## Hess-2019-242-RC1 Reply to Hessel Winsemius' comments

# Hess-2019-242-RC2 Reply to Claire Michailovsky's comments

Hess-2019-242-RC3 Reply to Paul Bates' comments

# Assimilation of wide-swath altimetry observations to correct large-scale river routing model parameters

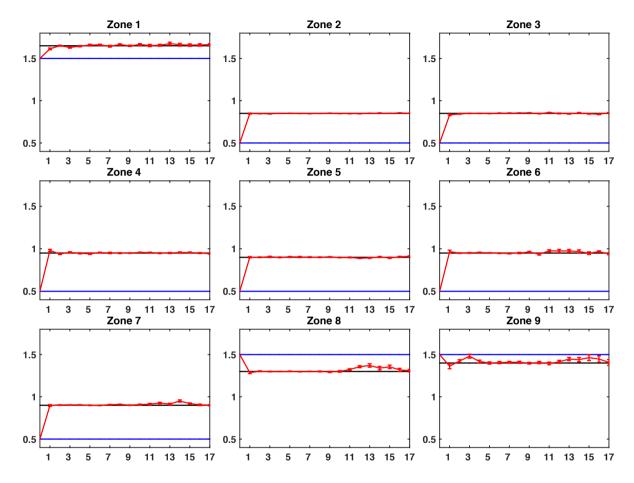
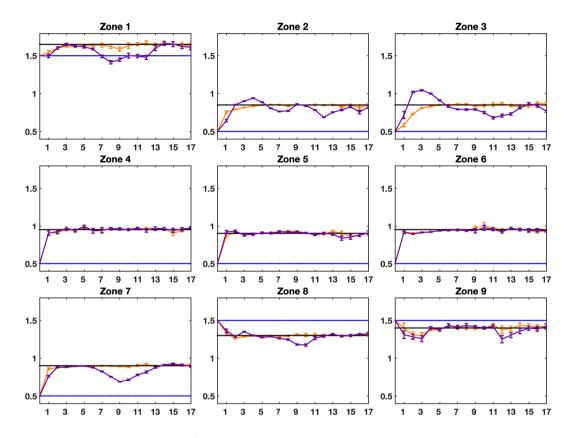
Following the reviewer's suggestion and a similar comment from reviewer #2, we re-worked the figures, namely Figures 7 to 10.

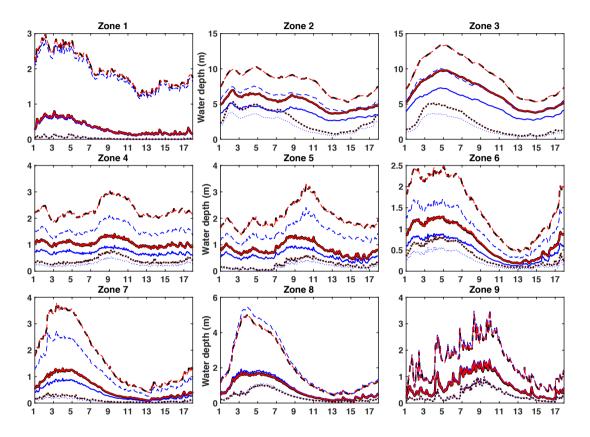
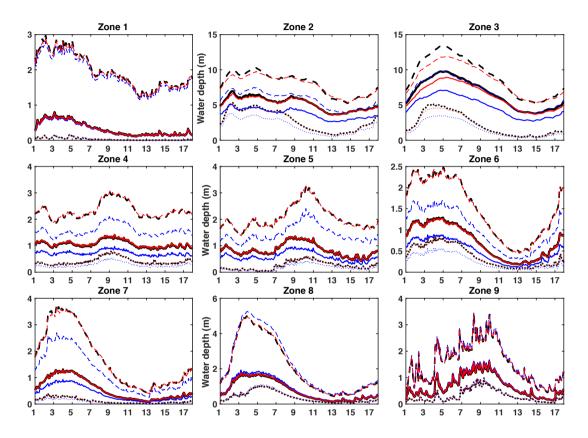
#### m#6 - Figure 8: the black lines cannot really be seen, perhaps increase the width?

Thank you for this suggestion. We modified Figures 8 and 10 such that the different curves can be seen more easily.
